### ContiTech

#### Timing belt kit CT 1077K2/WP2 for Opel, Alfa, Fiat, Saab, Chevrolet Various 1.6/1.8 models from 2003 onwards

Fig. 3: Variant 2 – withdraw pin after fitting belt

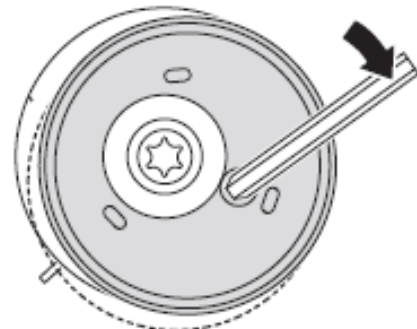
In the version with a prefitted pin, the pin is only withdrawn once the belt has been fitted. Here, too, the tension is then automatically set.
